RE: RPA NORTHWEST PRECINCT REDEVELOPMENT – RESPONSE TO TRAFFIC MATTERS

GTA Consultants has reviewed the traffic, on-site parking and loading matters as they relate to the Royal Prince Alfred Hospital (RPAH) Northwest Precinct Redevelopment and in particular comments by the Department of Infrastructure and Planning (DoPI), the City of Sydney (CoS) and Transport for NSW (TfNSW) in each respective letter of response to the project application (MP 10_0166) dated August 2012.

Attachment A

Brodie Street Shared Zone

RPAH NSW
SWEPT PATH ASSESSMENT
AMBULANCE

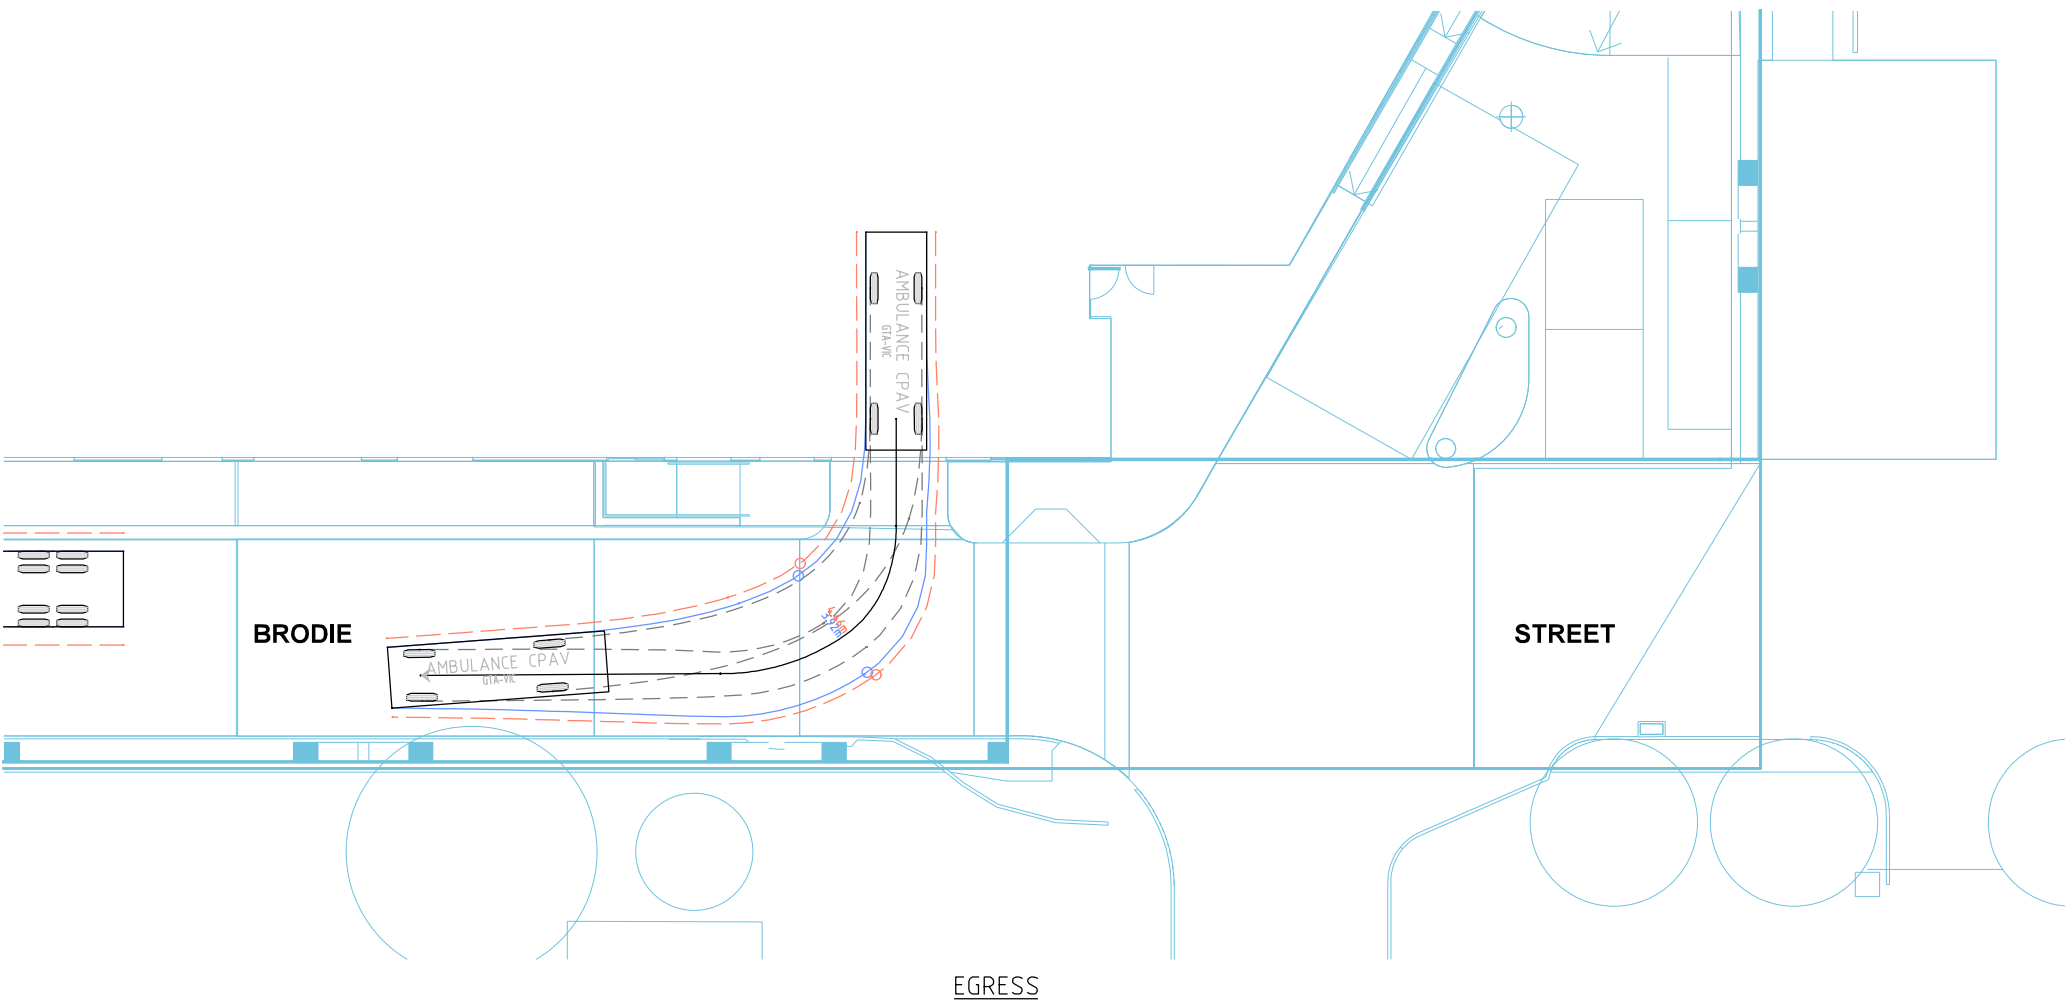
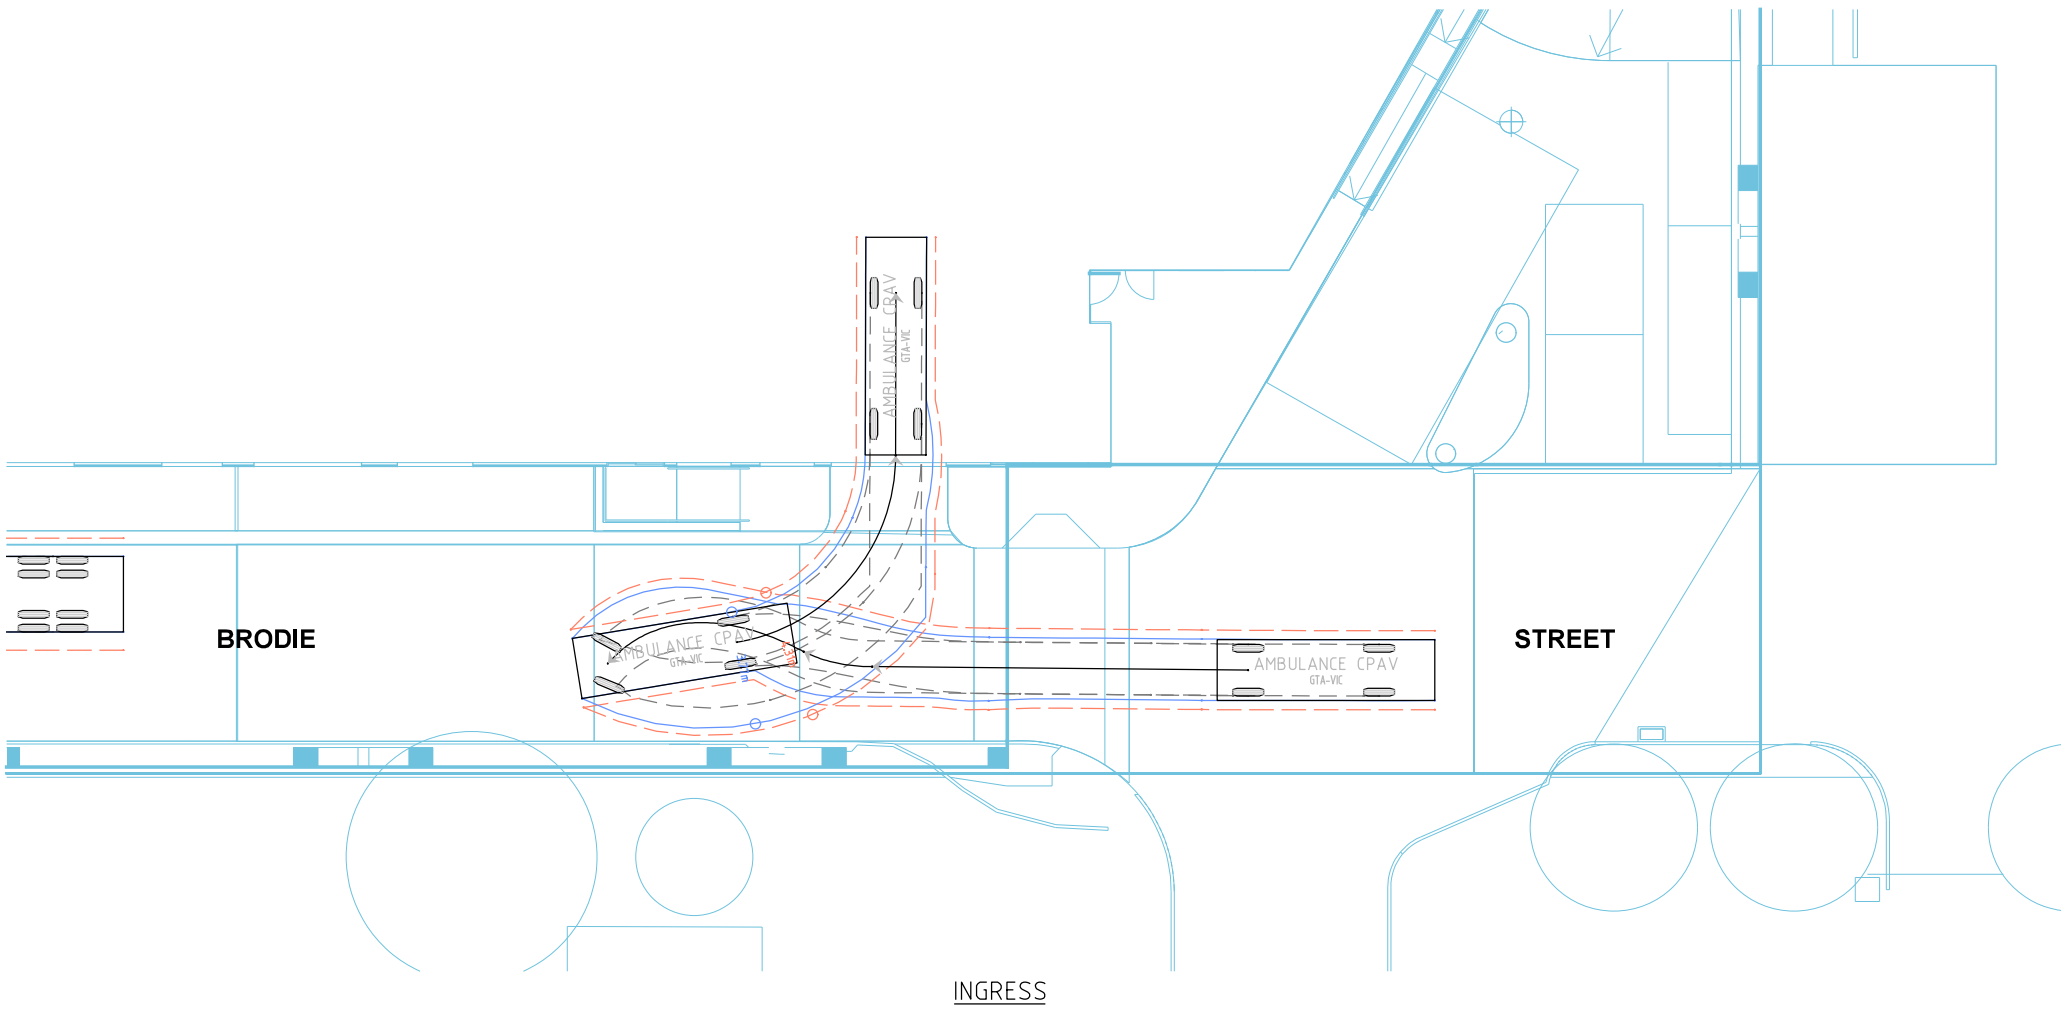
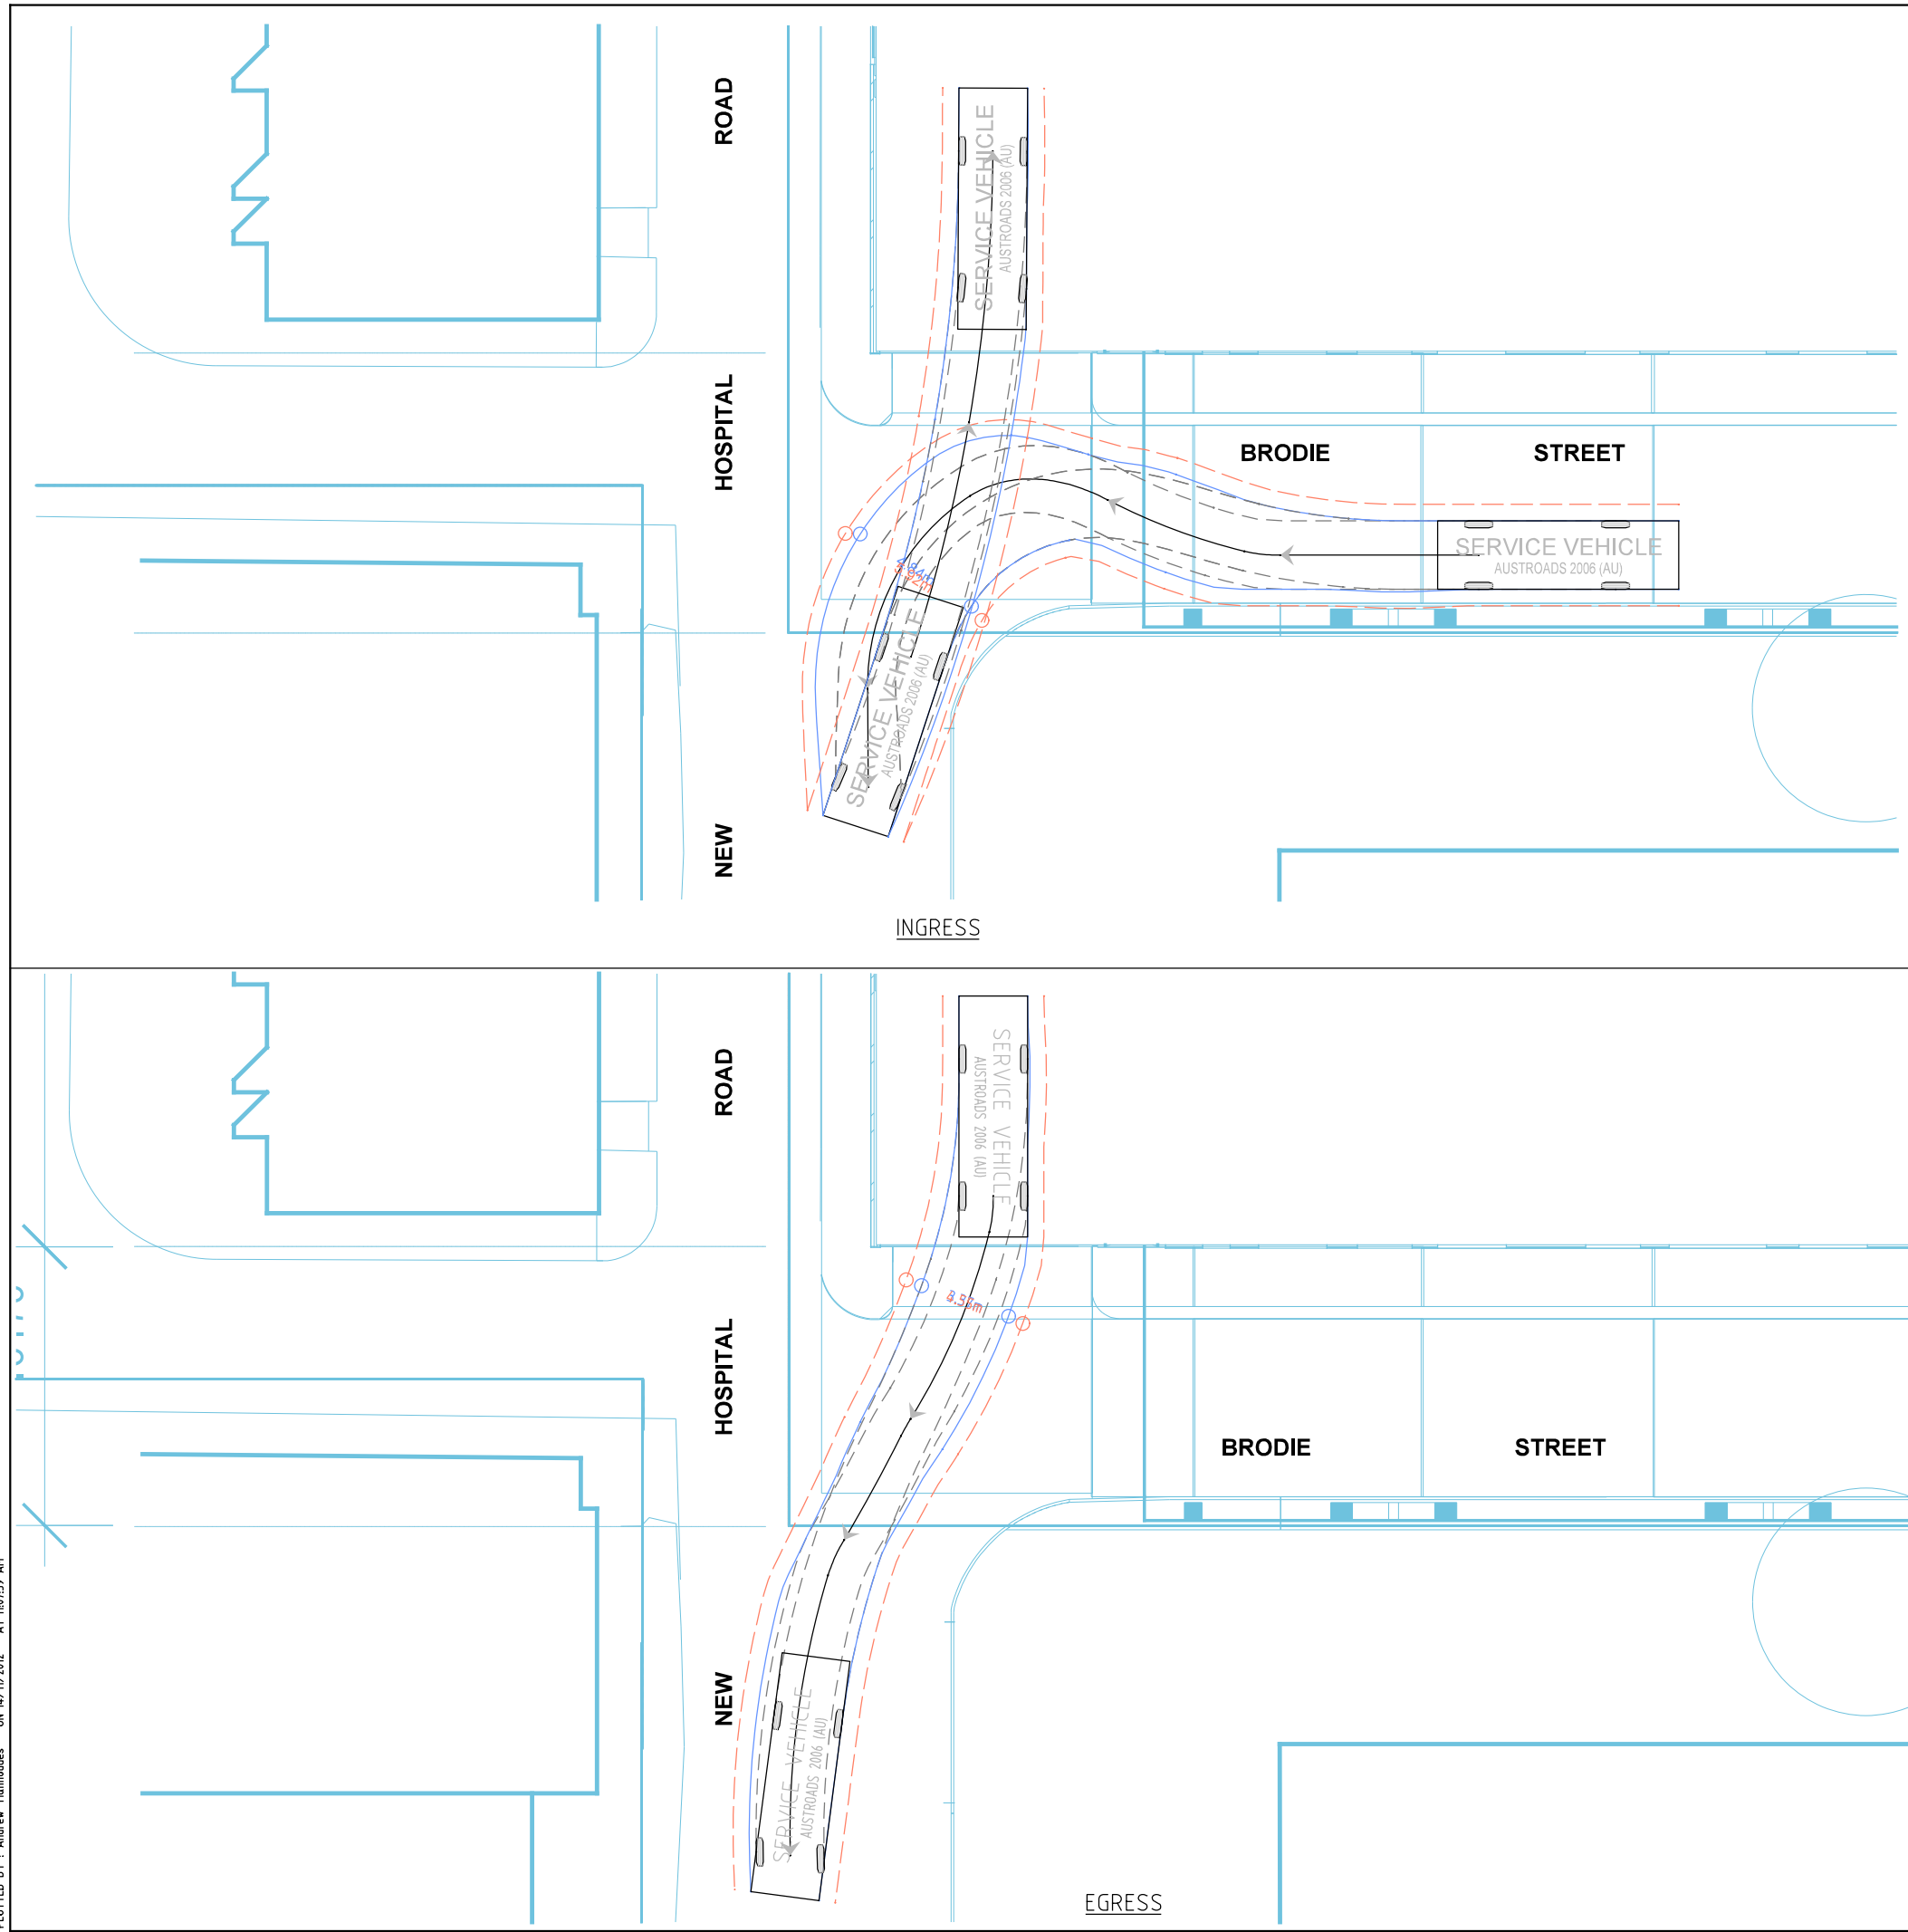
2. *Due to existing on-street parking on Lucas Street and Brodie Street, concerns are raised in regards to the local street being too narrow for adequate service vehicle and emergency vehicles access/egress. Service and Emergency vehicles trying to turn into Lucas Street and Brodie Street from Missenden*

Road, New Hospital Road and into the site may affect the efficiency of emergency response times due to the constraints of the street and site width. Additional information such as Swept Path Plans demonstrating the ability for such vehicles to manoeuvre in an adequate manner should be submitted to the DP&I for consideration.

Swept paths of all design vehicles are included in this response as Attachment B and show that the site and surrounding areas are able to be accessed by all vehicles.
